MEADOW BROOK ROAD Lot A-2

Application for Disposal Works Construction Permit

PLAN SHOWING SEWAGE DISPOSAL SYSTEM

Re: Subsurface sewage disposal system
plan reviews
East Leverett Road, Lots A-2, A-3, A-4

DEEP SOIL LOGS

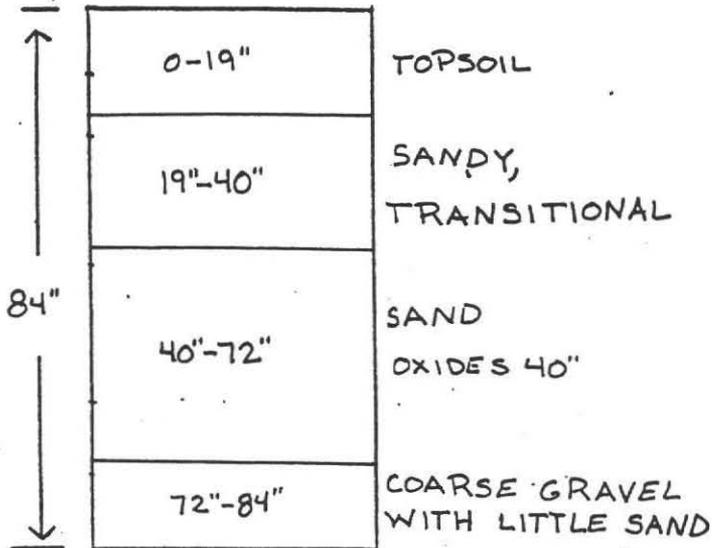
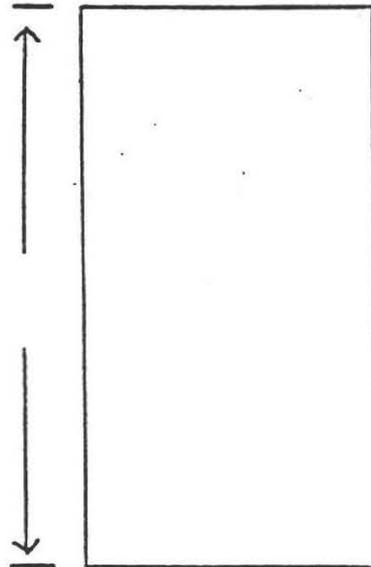
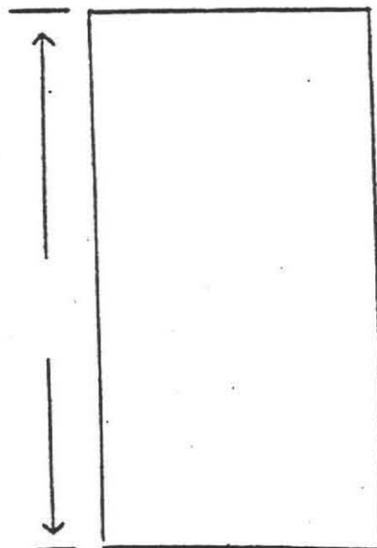
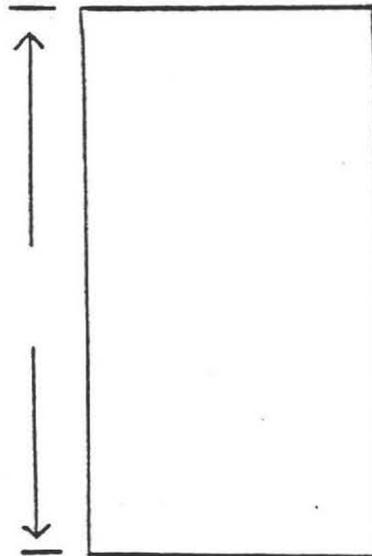
1. Soil log information submitted with the application does not show a minimum of six feet of naturally occurring pervious material in the proposed leaching system area (Town of Amherst supplemental regs.; reg.3).
2. Soil log information does not indicate to which lot this data corresponds

The test pit data is not identified either by lot designation or numbering sequence. In addition, a review of the original applications for these lots submitted October 21, 1987, revealed that the soil log information for lot A-4 was also submitted for Lot 2.

To resolve this matter, I would recommend that you have your engineers resubmit a copy of the preliminary plan of these lots with all of the deep test pits and percolation test pits located and identified.

PLAN SHOWING SEWAGE DISPOSAL SYSTEM

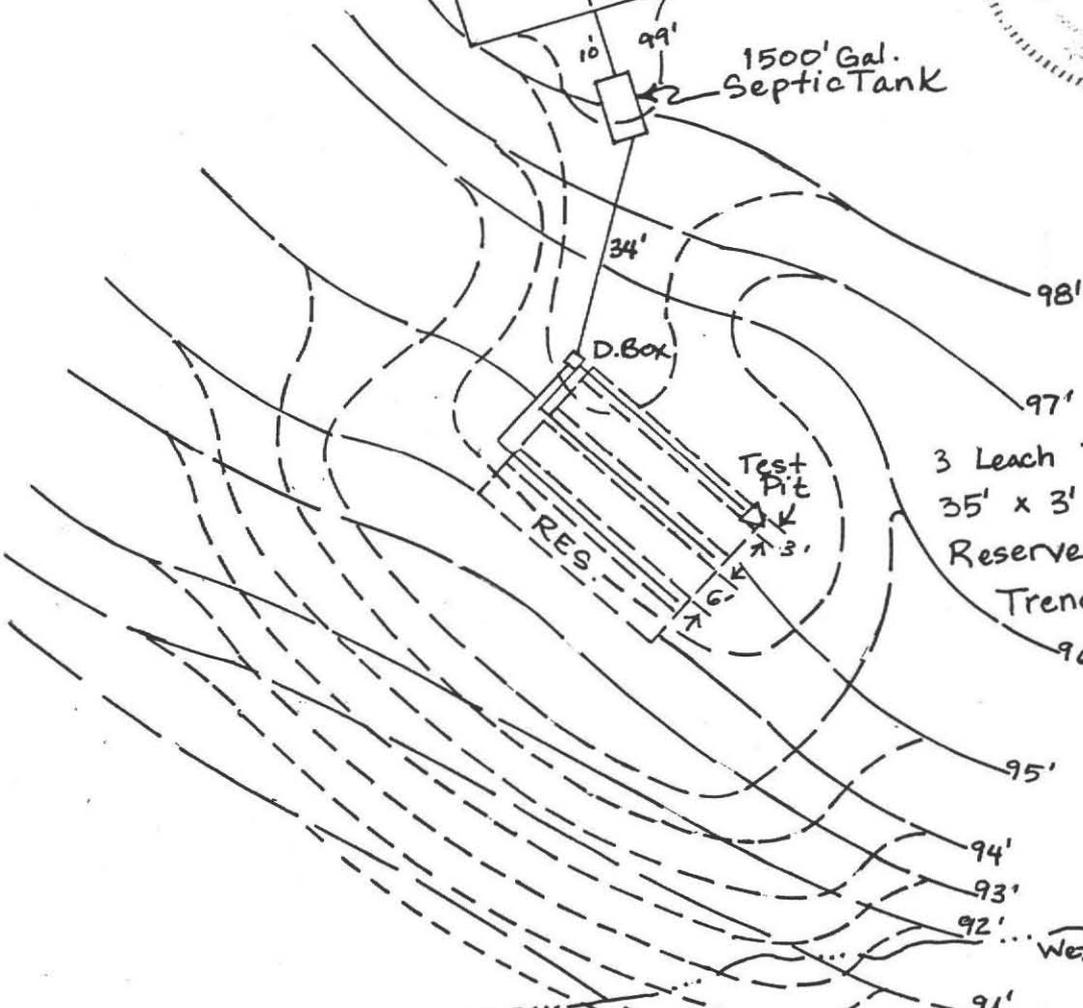
1. Soil log information does not show a minimum of six feet of naturally occurring pervious material as required by Amherst Health Department regulations (see comments previous section).
2. Percolation test pit location not shown on plan.
3. Soil log information not adequately identified on plan.
